Access Compliance Report Public Rights-of-Way (Curb Ramps)

Main Street: BALMORAL_PL Cross Street: MEANDERING_TRAIL Location: NW

ADA ID: RPRK211019144431 Ramp Type: Type 4 - Parallel Initial Pass/Fail: Fail Overall Compliance: No Severity Score: 30

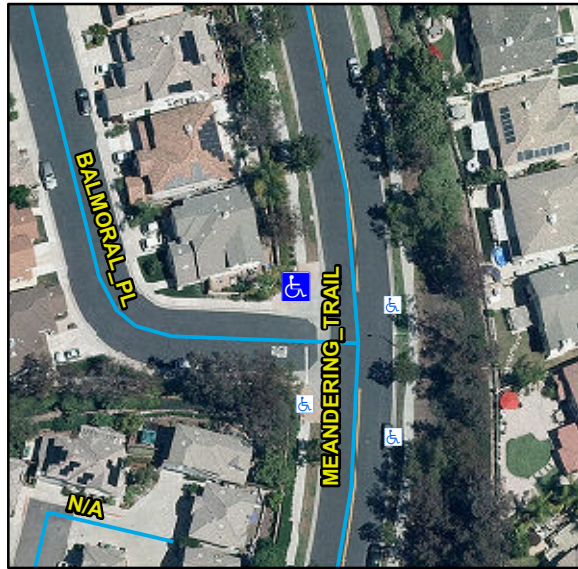
Surveyor Notes:

N/A

Compliance	Description	Data	Compliance	Description	Data
N/A	Ramp Length LT (in)	108	N/A	Ramp Length RT (in)	113
Yes	Ramp Width LT (in)	56	Yes	Ramp Width RT (in)	73
Yes	Ramp Run Slope LT (%)	1.2	Yes	Ramp Run Slope RT (%)	4.7
No	Ramp Cross Slope LT (%)	11.3	No	Ramp Cross Slope RT (%)	9.2
N/A	Landing Present	N/A	N/A	DWS Provided	N/A
N/A	Landing Length (in)	N/A	N/A	DWS Contrast	N/A
N/A	Landing Width (in)	N/A	N/A	DWS Length (in)	N/A
N/A	Landing Run Slope (%)	N/A	N/A	DWS Full Width	N/A
N/A	Landing Cross Slope (%)	N/A		DWS Offset Type	N/A
N/A	Landing Movement Obstructed?	N/A	N/A	DWS Offset Left (in)	N/A
	Landing Movement Type	N/A	N/A	DWS Offset Right (in)	N/A
N/A	Landing Shared	N/A			
N/A	Clear Space	Yes			
N/A	Clear Space To Crosswalk (in)	N/A			
N/A	Marked Crosswalk 1	No	N/A	Marked Crosswalk 2	No
	Crossing 1 Direction	S		Crossing 2 Direction	E
	Marked Crosswalk 1 Width (in)	N/A		Marked Crosswalk 2 Width (in)	N/A

Remove & Replace Curb Ramp With Two New Directional Ramps or Equivalent.

R204.3, R304.5.3, STD 1115
